Re: Proposed Revision to the State Implementation Plan for PM2.5 for Allegheny County – Liberty-Clairton Area Attainment Plan

Executive Summary for Comments of Citizens for Pennsylvania's Future and The Group Against Smog and Pollution on the Proposed Attainment Demonstration for the Liberty-Clairton PM2.5 Nonattainment Area

**COMMENTS OF CITIZENS FOR PENNSYLVANIA'S FUTURE AND THE
GROUP AGAINST SMOG AND POLLUTION ON THE PROPOSED
ATTAINMENT DEMONSTRATION FOR THE LIBERTY-CLAIRTON PM2.5
NONATTAINMENT AREA**

Figure 1: Occupied Homes in Areas Modeled to Exceed the 15 $\mu\text{g}/\text{m}^3$ Annual Standard

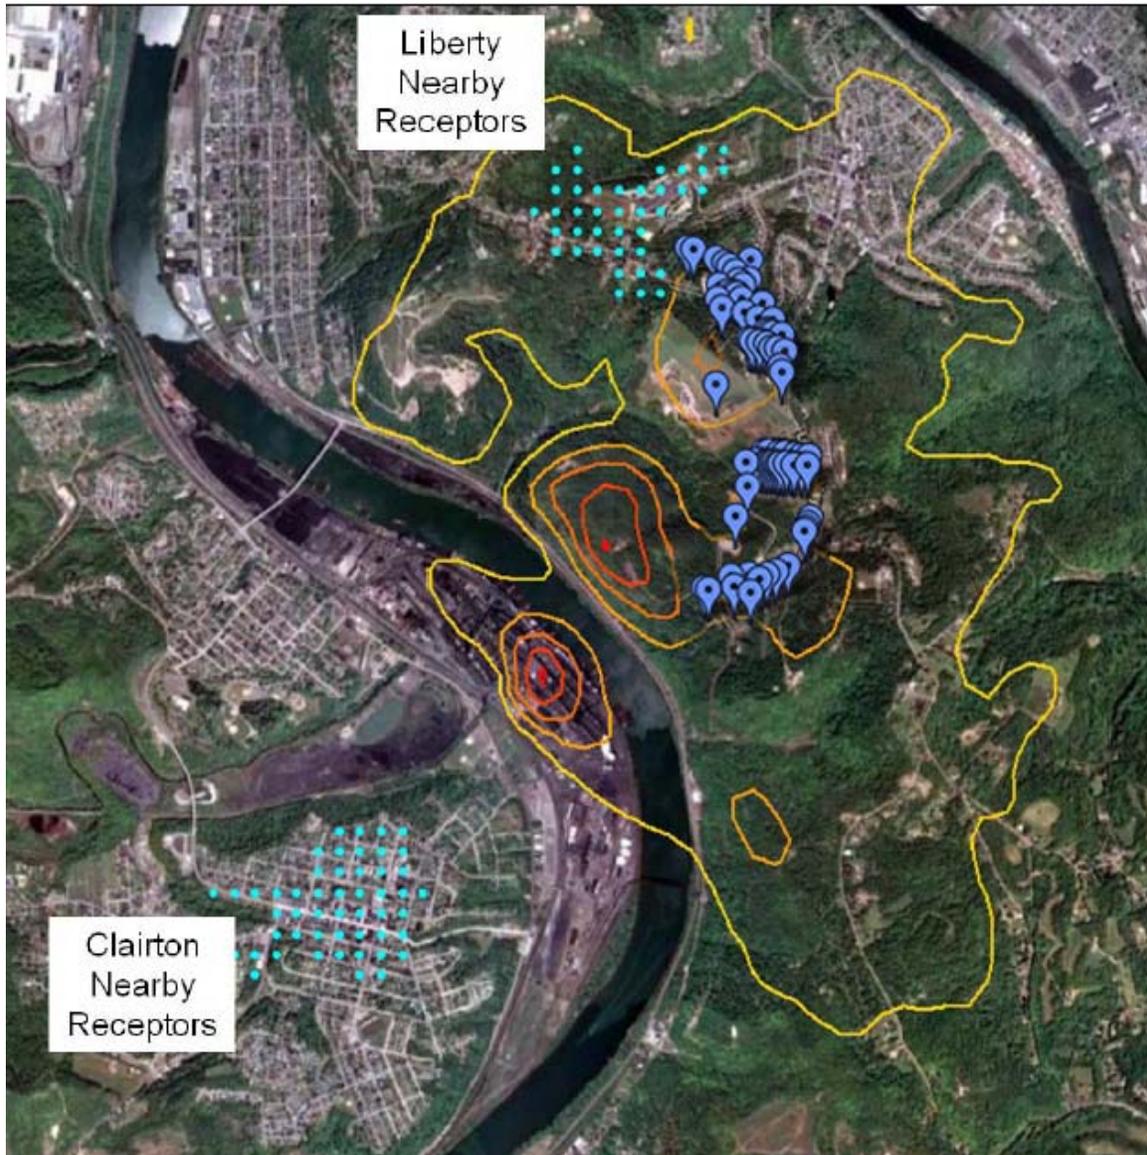
The SIP’s analysis does not fully satisfy EPA’s guidance because it does not quantify the incremental concentrations in this area, which must be known to determine the extent of additional control measures that are needed to achieve the emission reductions that would provide for attainment in this area. Despite this omission, the analysis provided by the ACHD nonetheless shows that the NAAQS will not be met in this area because the attainment demonstration for the Liberty Borough monitor predicts that the annual concentration at that location in 2015 will be 14.9996 µg/m³, only 0.0004 µg/m³ less than the maximum concentration permitted under the NAAQS. The higher, but unquantified, concentrations in the Lincoln area will obviously violate the NAAQS.

The SIP attempts to justify this omission by arguing that the health and welfare of the residents in this high pollution zone may be sacrificed because “the Lincoln hillside is not suitable as a neighborhood-scale location for analyzing PM_{2.5} because it does not represent a populated area.”⁷ To test this assertion, GASP surveyed the area expected to be affected (within red and orange lines marked on Figure 8-1), and found 80 occupied homes.⁸ The residents of this neighborhood must not be consigned to lifelong exposure to pollutant levels that are known to be deadly.

- Direct the staff at ACHD to perform additional air quality modeling using dispersion models to determine the additional reductions of direct particles emitted from sources within the nonattainment area that must be obtained to provide for attainment of both the annual and revised 24-hour Standard at all residences in the County where exposure to fine particle pollution is expected to be higher than at the monitor in Liberty Borough.
